**TO:** Development Review Board  
**FROM:** Scott Gustin  
**DATE:** October 4, 2011  
**RE:** 12-0322CA; 645 Pine Street

**Request:** Construct concrete vehicle wash-down structure with enhanced oil/grit separator

Washdown Profile (Scale: 1" = 5')

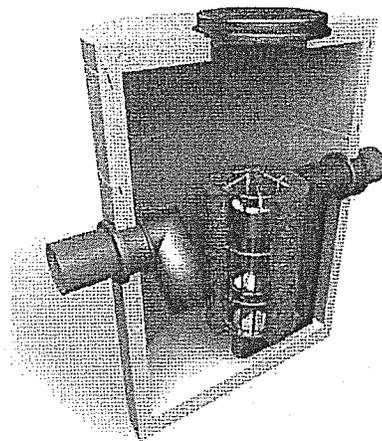
The heights of the concrete walls are not specified and must be; however, they are clearly well below the 15' height limit for accessory structures. **(Affirmative finding as conditioned)**

1. **Prior to release of the zoning permit**, the height of the wash station structure shall be noted, subject to staff review and approval.
2. This approval incorporates the Erosion Prevention and Sediment Control Plan approved by Megan Moir (Stormwater Administrator) September 7, 2011.
3. It is the applicant's responsibility to comply with all restrictions as established by Vermont Dept. of Environmental Conservation for excavation on this property.
4. The proposed structure shall comply with Burlington's current building code requirements as established by Burlington Public Works.
5. Standard permit conditions 1 -18.
